Access Compliance Report

Public Rights-of-Way

Intersection ID: 13682	Main Street: E_8TH_ST	Cross Street: LAMAR_AV	Location: W
ADA ID: 7AF2594F21C4	Ramp Type: BlendTrans1	Initial Pass/Fail: Fail	Overall Compliance: No
		Severity Score: 8.75

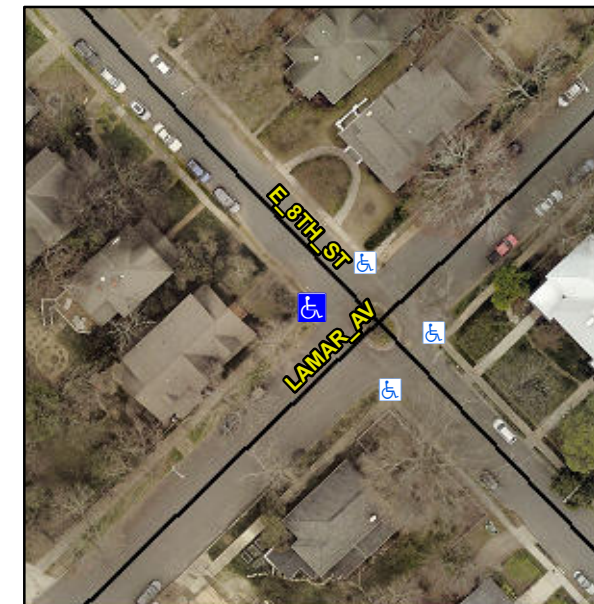
R304.5.1

Remove & Replace Curb Ramp With Two New Directional Ramps or Equivalent.
